Data Request #	Section/ Page	Section	Topic	Information Request	Applicant Response
Veg-4	Part 4.8; Attachment L	Vegetation	Revegetation	Provide information clarifying how revegetation will lead to restoration. Within the WDFW Wind Power Guidelines, temporary impacts to habitats are those that are restored following construction. Within the definition “the goal of restoration of temporary impacts should be to restore habitats to a condition at least as good as its pre-project condition”.	The Vegetation and Weed Management Plan (to be provided in September 2023) will outline the native seed mixes that will be used during revegetation efforts in both grassland and shrubsteppe communities. Attempts to minimize temporary disturbance will be made, particularly temporary disturbance to shrubsteppe communities, which take longer to reestablish during revegetation. Revegetation of grasslands will be completed by the end of the growing season that follows the completion of construction. This will allow for reseeding during post-construction and ample time for the site to receive adequate rainfall, which is a limiting factor for revegetation in Eastern Washington. Shrubsteppe communities will

Attachment Land Use-25

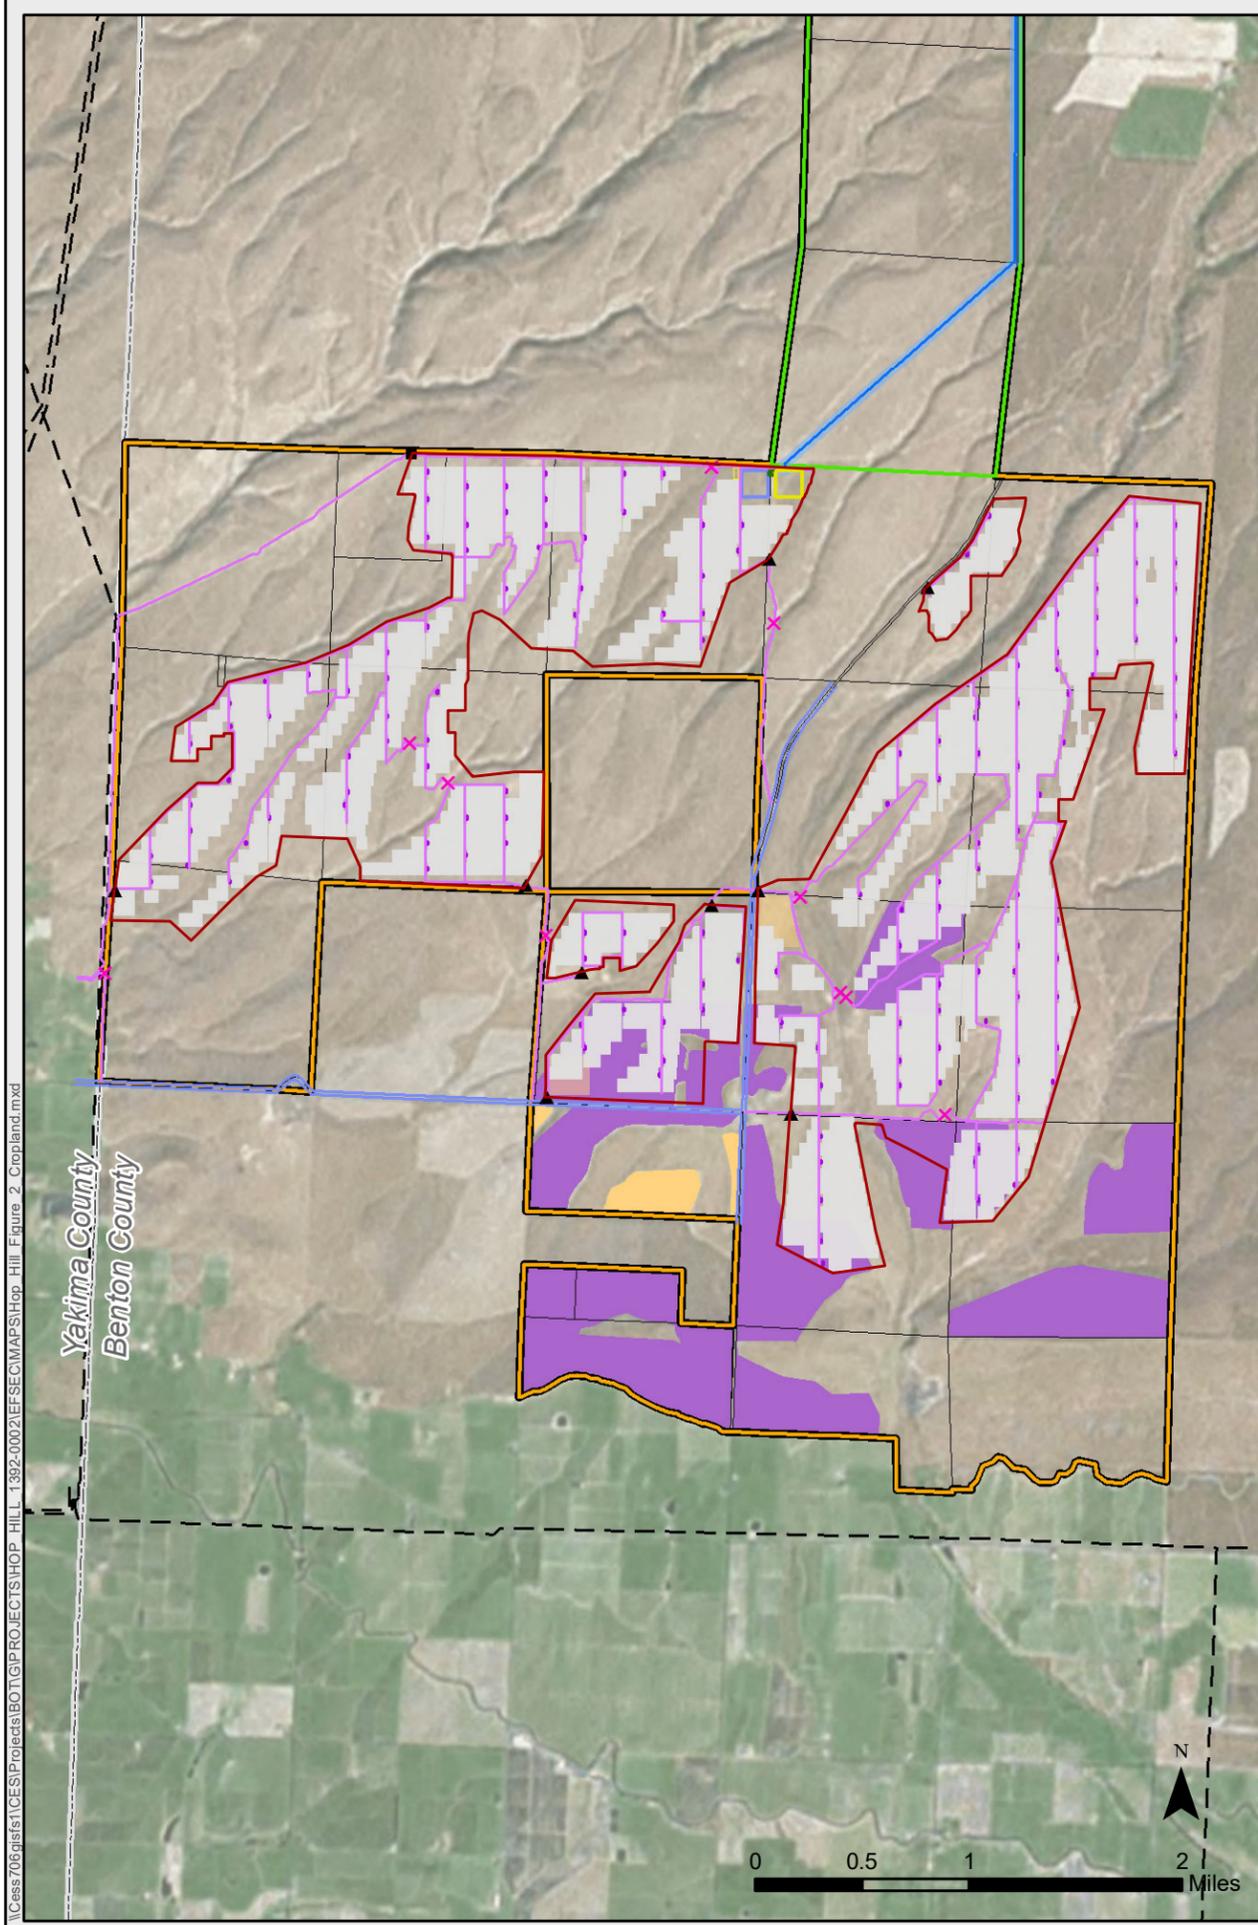
Land Use-24	Attachment D	Land Use, Natural Resource Lands & Shoreline Compatibility	Solar panels and other project components within the Siting Area	Provide a new figure, presenting Figure 3 in Attachment D of the ASC with an overlay of solar panels and other project components within the Siting Area for better presentation of prime farmlands that will be permanently disturbed.	Figure 3 to Attachment D of the ASC is revised and attached to include the preliminary site plan as updated and provided to EFSEC on April 26, 2023. See Attachment Land Use-24 .

Figure 2 WSDA Cropland

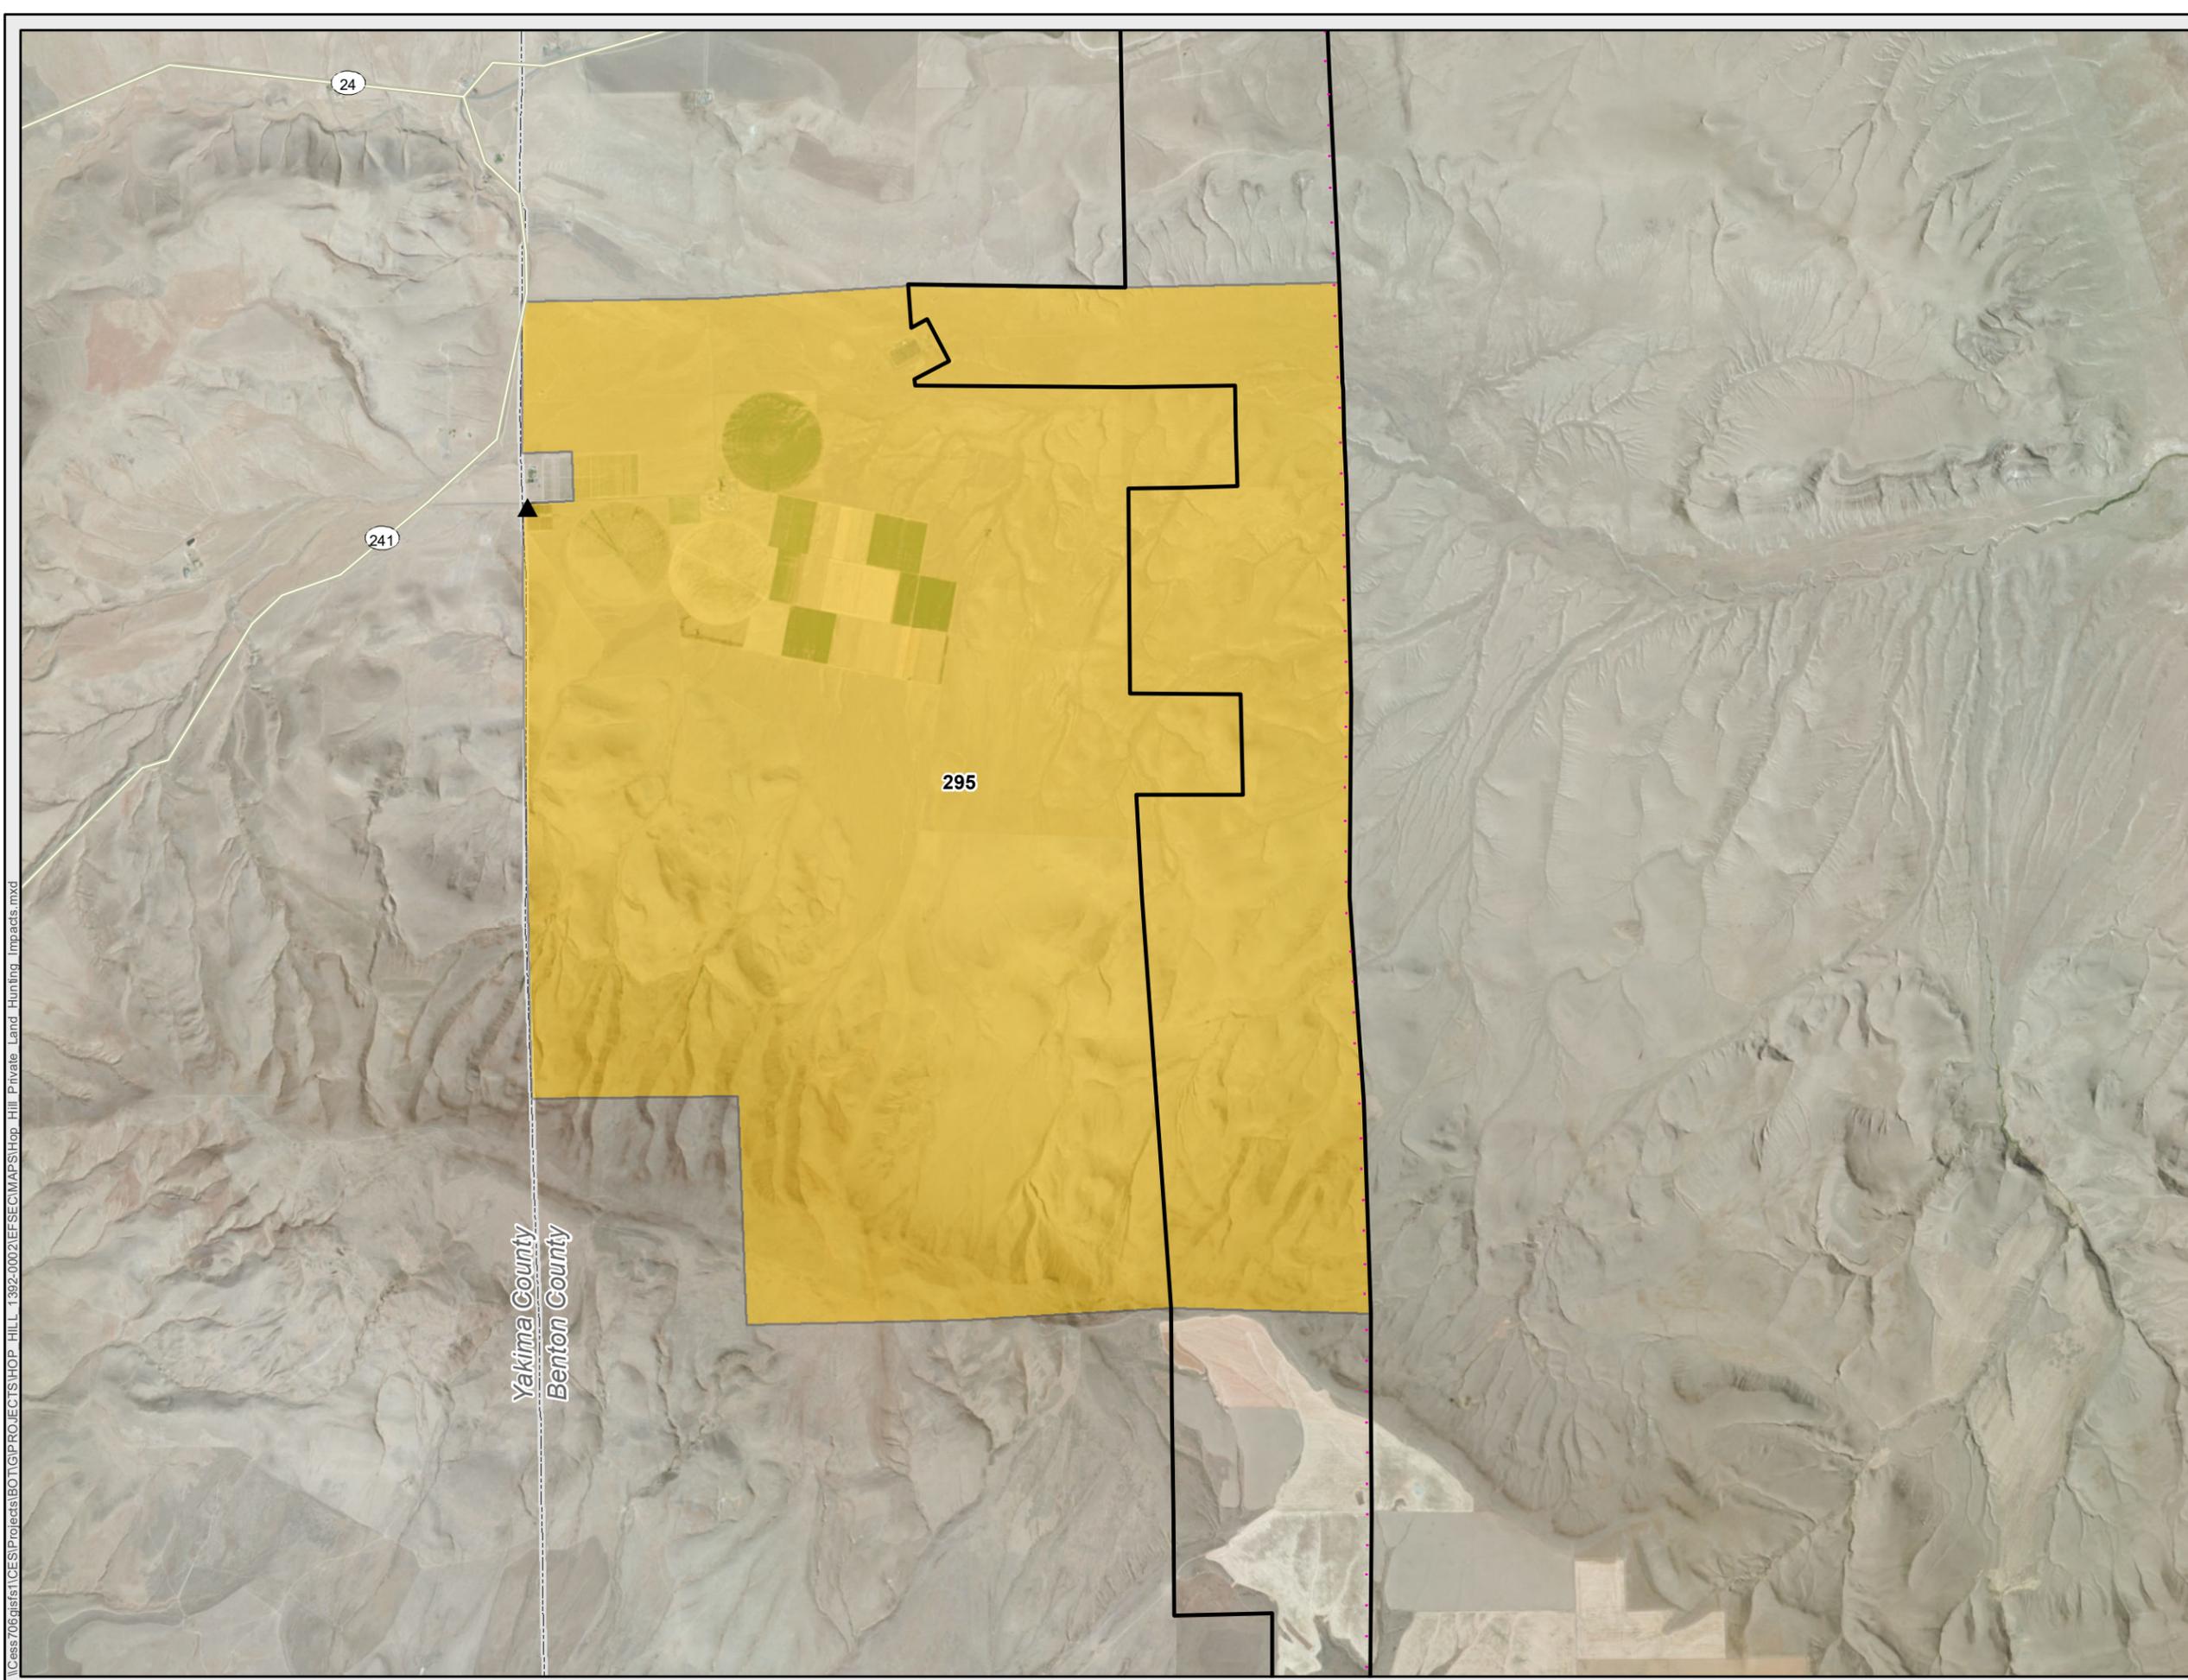
Data Request #	Section/ Page	Section	Topic	Information Request	Applicant Response
Land Use-25	Attachment D	Land Use, Natural Resource Lands & Shoreline Compatibility	Solar panels and other project components within the Siting Area	Provide a new figure, presenting Figure 2 in Attachment D of the ASC with an overlay of solar panels and other project components within the Siting Area for better presentation of WSDA-mapped croplands that will be permanently disturbed including lands identified for vineyards and Conservation Reserve Program	Figure 2 to Attachment D of the ASC is revised and attached to include the preliminary site plan as updated and provided to EFSEC on April 26, 2023. See Attachment Land Use-25 .
Land Use-26	pt. 1 pg. 5	Land Use, Natural Resource Lands & Shoreline Compatibility	There is a potential to expand the Project in the future to accommodate growing local, regional, and industrial renewable energy demand. Before the Applicant commits to expanding the solar site, the Applicant wants to ensure the expansion will be able to maintain the same development standards as the initial Project including agrivoltaics and a thoughtful approach to cultural and natural resource preservation.	Have lease agreements been made/secured to enable future expansion?	BrightNight does have land secured that could be used for an expansion of the Project. However, BrightNight is focused on developing the first 500 MWs of the Project and will explore expansion plans with local and state stakeholders when a need develops in the regional energy market.
